591, 593 COBBITTY ROAD &
1 FRESHWATER DRIVE, COBBITTY
(PRECINCT 2A STAGE 1 &
TRANCHE 5a STAGE 1)
ROAD & DRAINAGE DESIGN

ISSUED FOR SUBDIVISION WORKS CERTIFICATE

WORKS AS EXECUTED
WORKS AS EXECUTED INFORMATION SHOWN IN RED.
DATE: 15/09/2025

Title: DRAINAGE LONGITUDINAL SECTIONS SHEET 11				
Project No.	Set No.	Milestone	Plan	Revision
23-0579	01	SWC	520	D

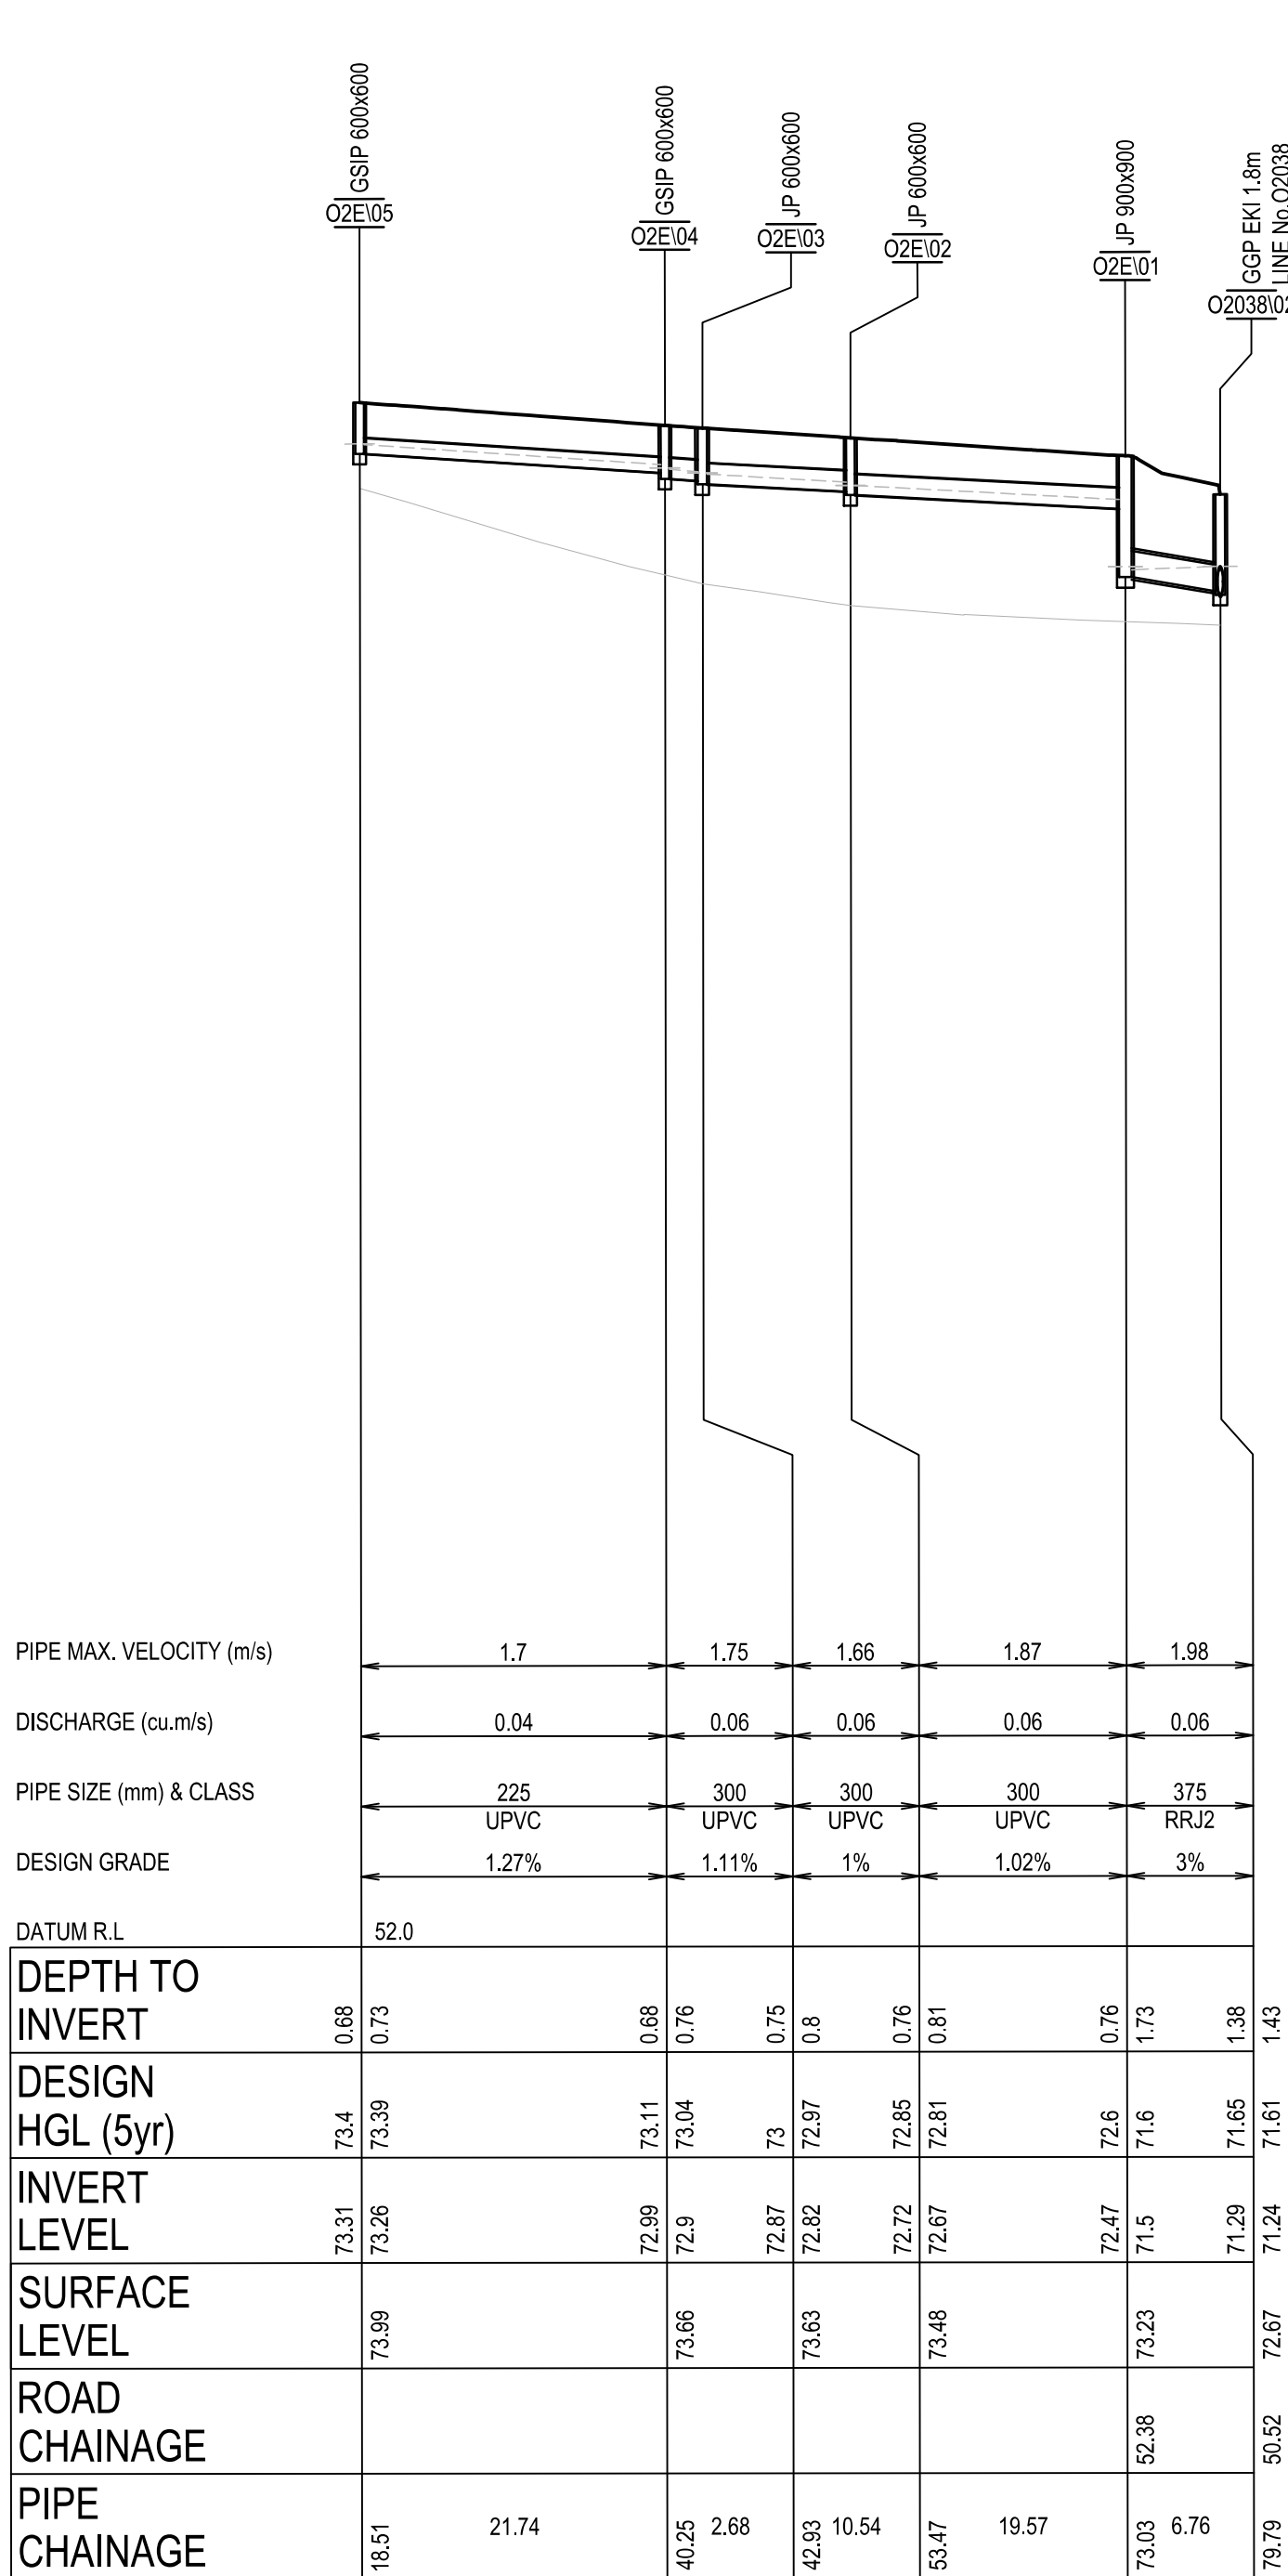
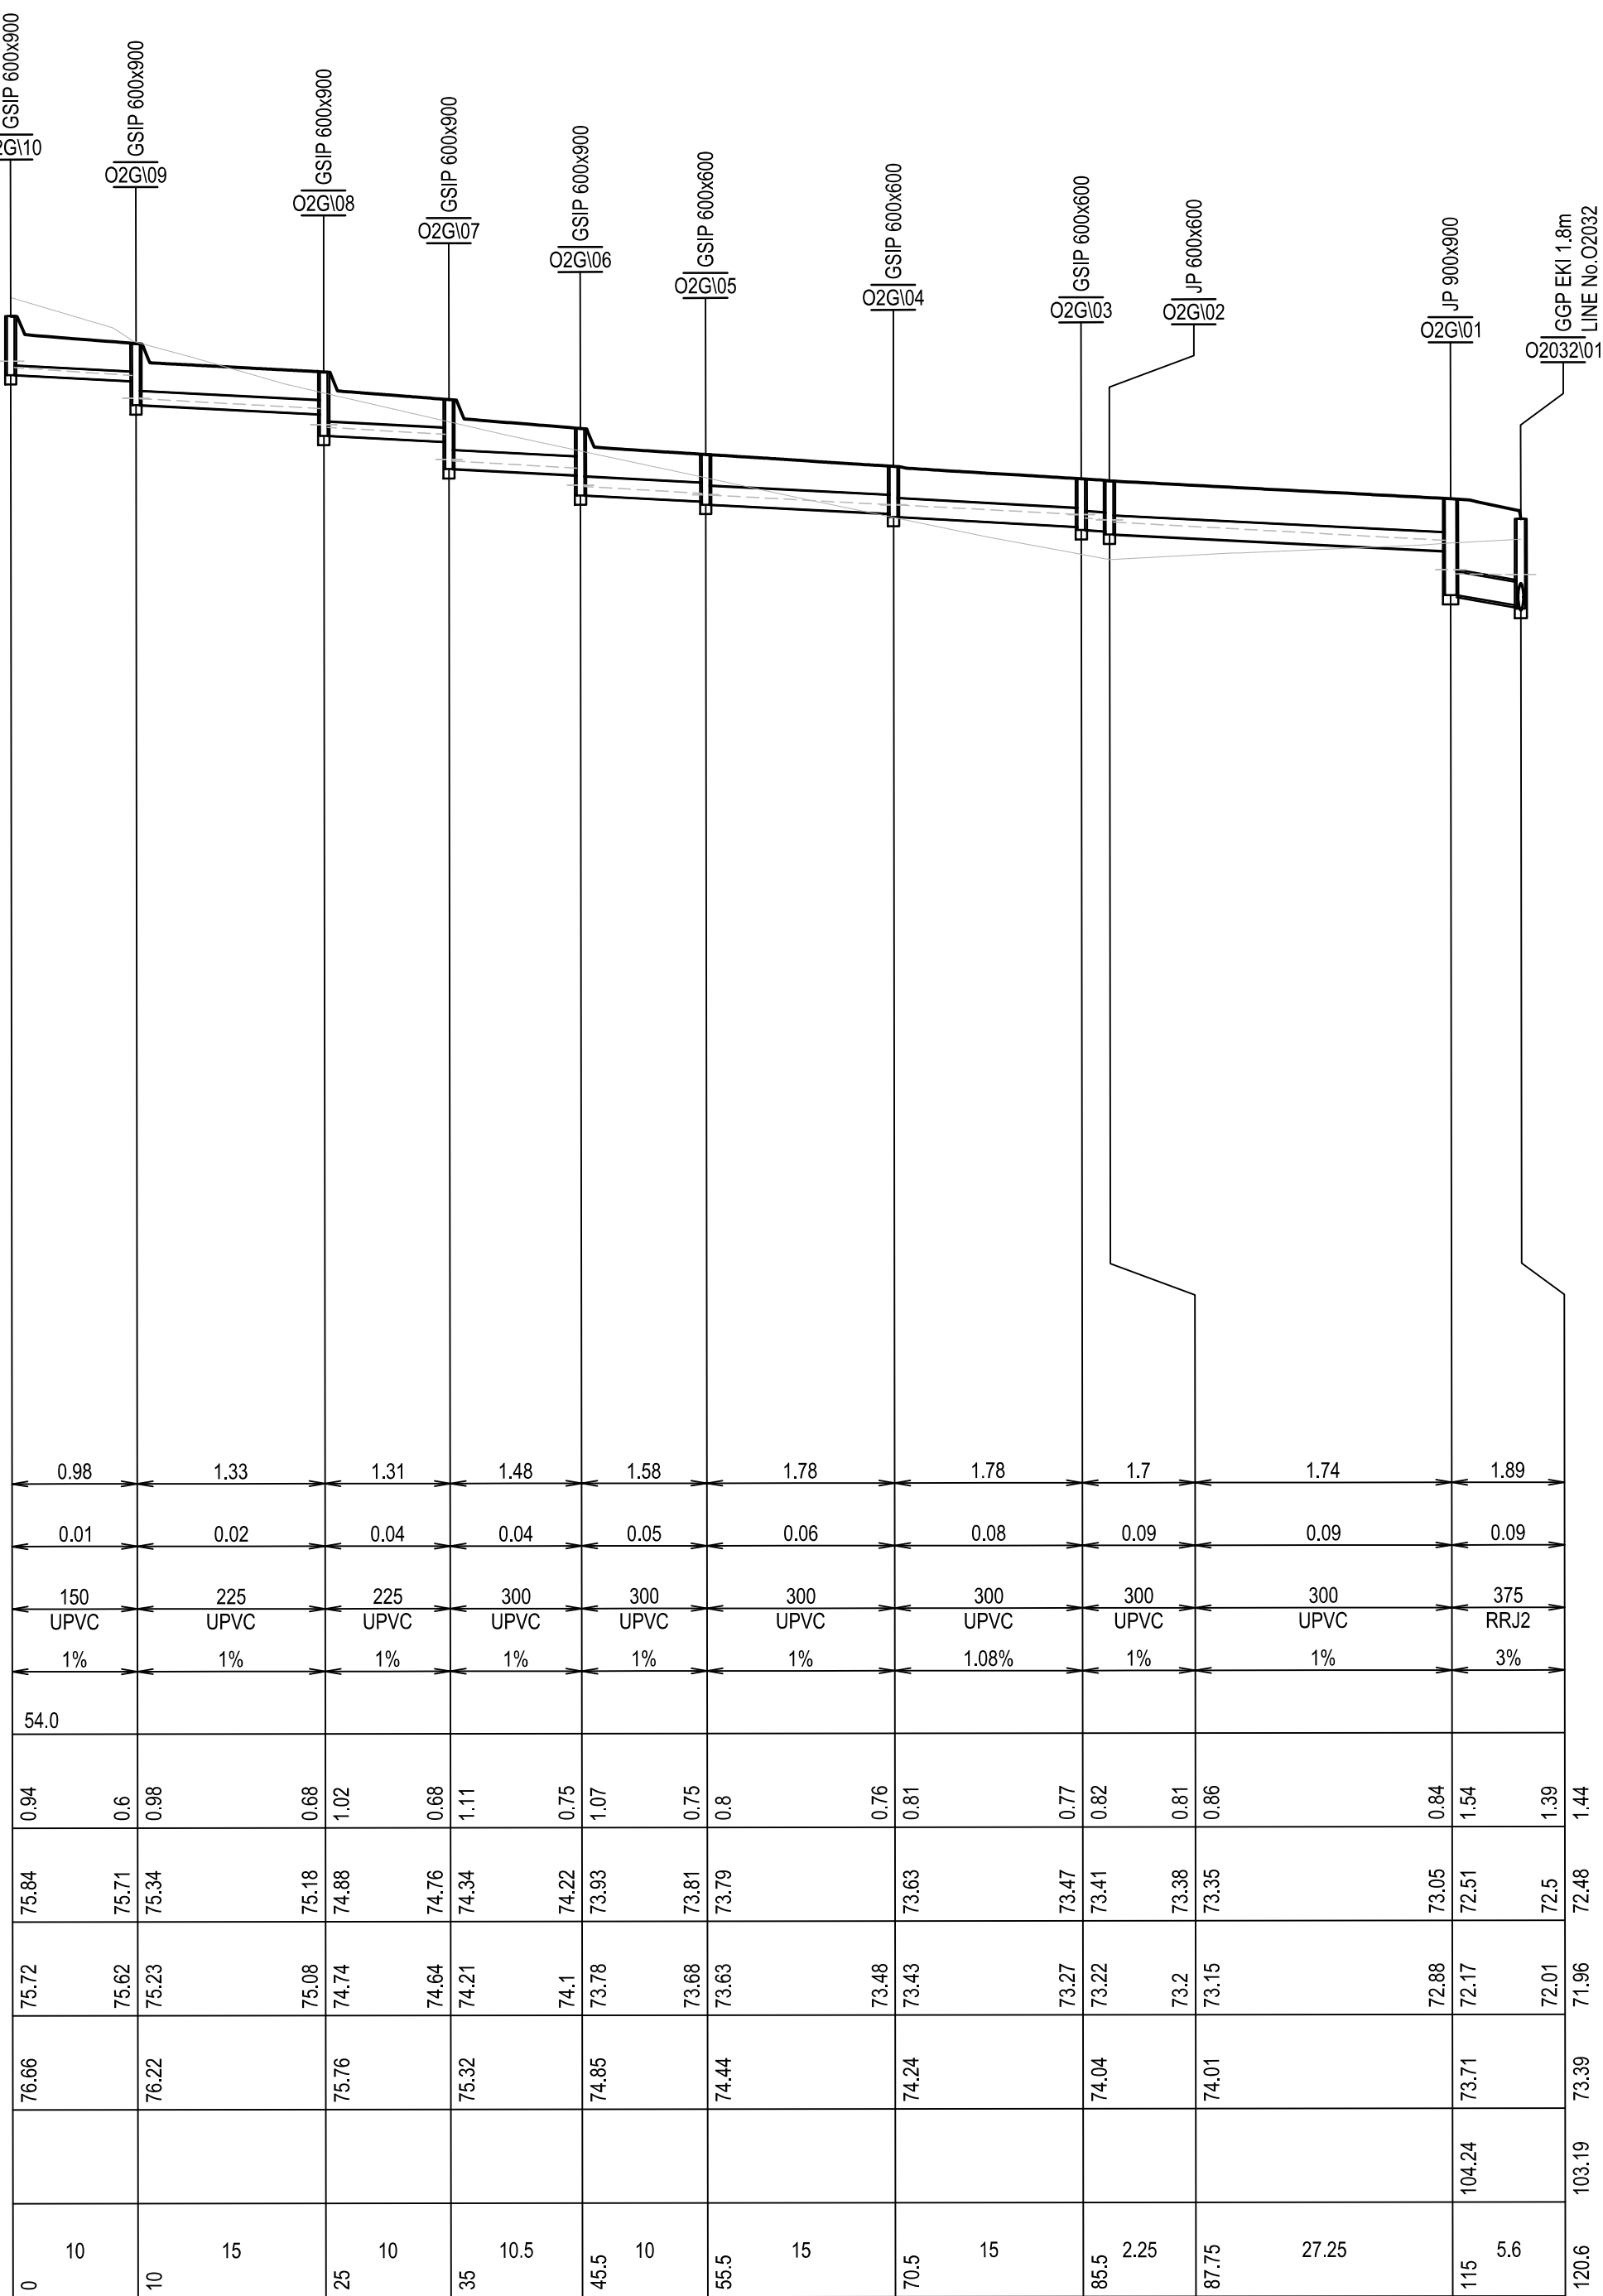
*PIPE O2000 UPSIZED
*PIT NUMBERS AMENDED
*HGL LOWERED
